Notice of Administrative Decision

RE: **Permit Number:** 18-00731
Project Name: Silver View Apartments ACUP Hearing Examiner Remand and Appeal
Type of Application: Administrative Conditional Use Permit (ACUP)

Administrative Staff Report

Project Name: Silver View Apartments Hearing Examiner Remand and Appeal

Diagram of Pedestrian Improvement Frontage improvements

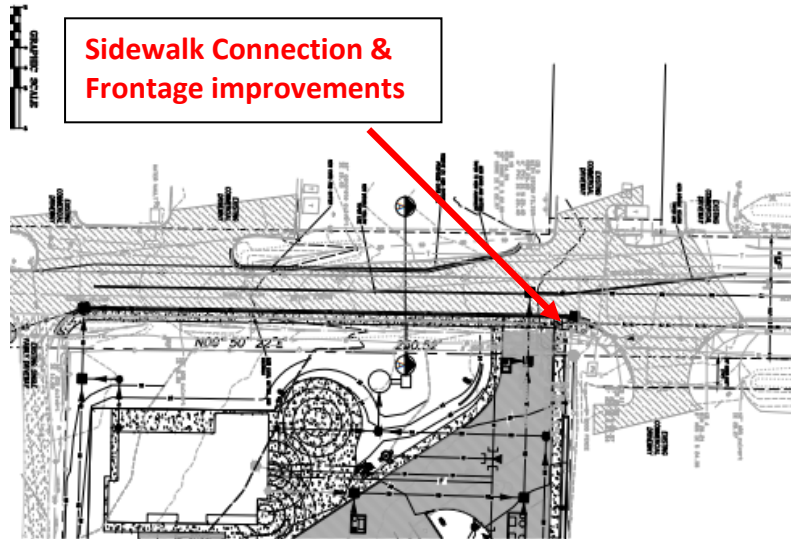
The project was reviewed for potential pedestrian and vehicular traffic impacts, which included analysis of adjacent intersections to monitor the vehicular level-of-service. There are property frontage improvements required along Mickelberry Road NW consisting of an 11-foot travel lane and 5-foot sidewalks. (Please see Condition 35).

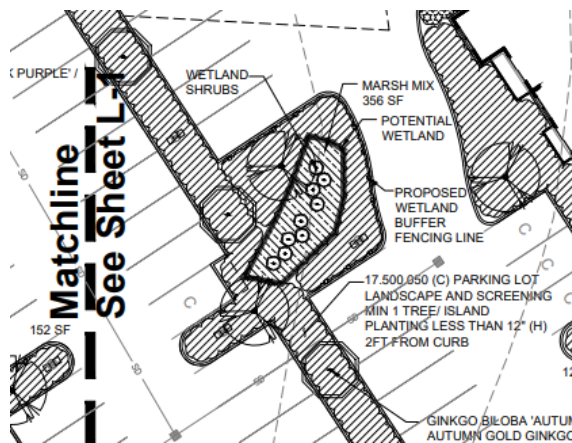
The project proposed to collect stormwater runoff from a majority of the developed project site area into a proposed storm conveyance system where it will be treated for water quality prior to discharging into a new storm system to be constructed within Mickelberry Road NW. The new storm system will convey stormwater to the existing storm system located in NW Bucklin Hill Road. Connection will be to an existing Type 2 Manhole located along the flow line of south side of NW Bucklin Hill Road. This stormwater connection from the site will be conveyed to the existing 48-inch diameter storm water from the site will be conveyed to the existing 48-inch diameter storm pipe, stormwater from the site will flow approximately 700 feet west where the storm pipe empties into Dyes Inlet at the same location where the stream of Clear Creek empties into Dyes Inlet. The connection of the storm system into Dyes inlet and the fact that the existing system has adequate capacity, direct discharge without detention is allowable for this site.

The remainder of the drainage on the project site will be collected, treated, and conveyed to a second new storm system which will also collect the offsite runoff. This stormwater will then be discharged to the natural discharge location at the southwest corner of the project site. The storm runoff released to the natural discharge point has been designed to be less than the runoff released from the site in the current condition and as such no additional detention will be required. Staff comments are based on review of the latest amended Preliminary Storm Drainage report, and engineering plans accepted for review on July 19, 2022. Development Engineering and third party reviewer

accepts the storm drainage design and issued preliminary conditions of approval dated December 12, 2022 (see Storm Drainage Plan Attachment - B).

1. Code Requirements/Parking Reduction issue (Findings of Fact 10)

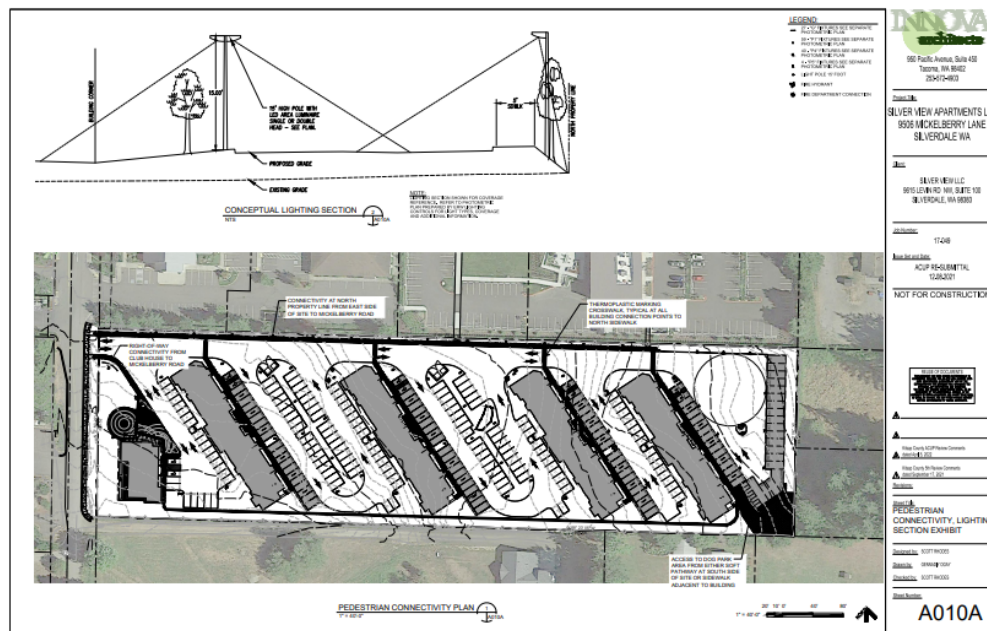
Hearing Examiner Comment (HE): While the code does authorize a parking reduction based on public transit reducing the parking demand, the ACUP and record are confusing on the mitigation being provided and the ACUP does not detail how transit will operate to reduce parking demand. Improving transit access may accomplish this objective. But the ACUP does not detail how, and the actual mitigation imposed requires clarification.

Applicant Response: The project provides 245 parking spaces, which is 25% or 75 less than KCC 17.490.030 otherwise requires for apartments (1.5 per unit plus .5 on street or set

Staff Response: The applicant demonstrates through mitigation that the parking standard exceeds demand which is allowed pursuant to WAC 468-63 and KCC 17.490.030. Project provides pedestrian access through the site to Mickelberry Road. Project includes frontage improvement along Mickelberry Road (curb gutter and sidewalk). Residents with bus passes will be able to use pedestrian access to the bus stop located on Bucklin Hill Road.

Colored Site Plan – Project layout

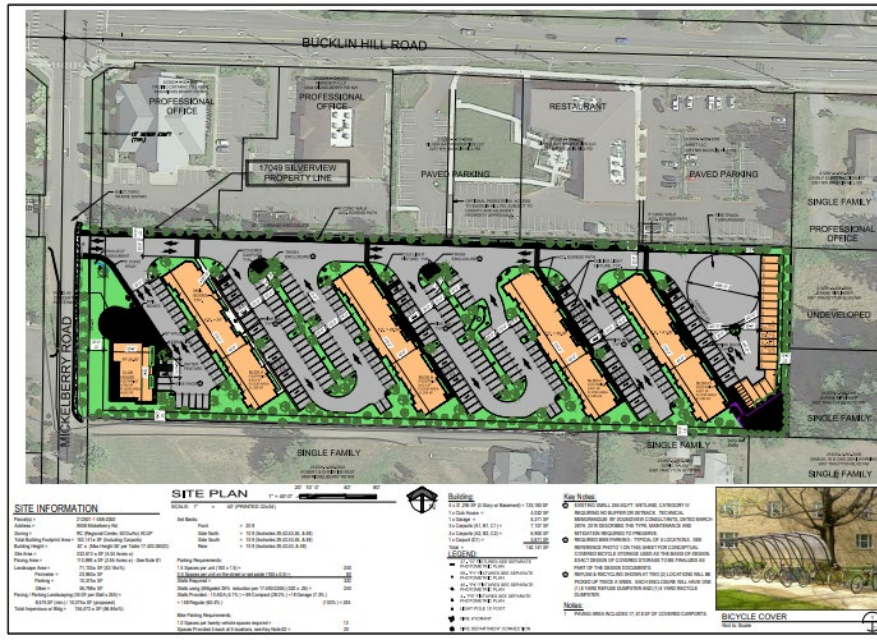
HE Comment: Per the Hearing Examiner Finding #16, the project site plan and narrative do not demonstrate compliance with the Silverdale Design Guidelines Section 9.4.3A., requiring parking to be oriented to the side or rear yard. Mr. Adams detailed how the project does not comport with the Design Standards. The Design Standards (and Comprehensive Plan) require the project to be respectful of single-family development (see Comprehensive Plan LU Goal 1 and Policy 1) (*See design standards -Revised Architectural Narrative Response to County Comments, July 15, 2022*).

Staff Response: Staff concurs the project can operate as a transitional use between the more intensive commercial uses along Bucklin Hill Road to the north within the RC zone and provides a separation between the UR zone and associated single-family homes. The site plan shows the more intensive activities such as off-street parking adjacent to the RC zone. The building profiles show the apartment building stepped down with a screening buffer along the south and east property lines which reduces impacts to the Urban Restricted zone.
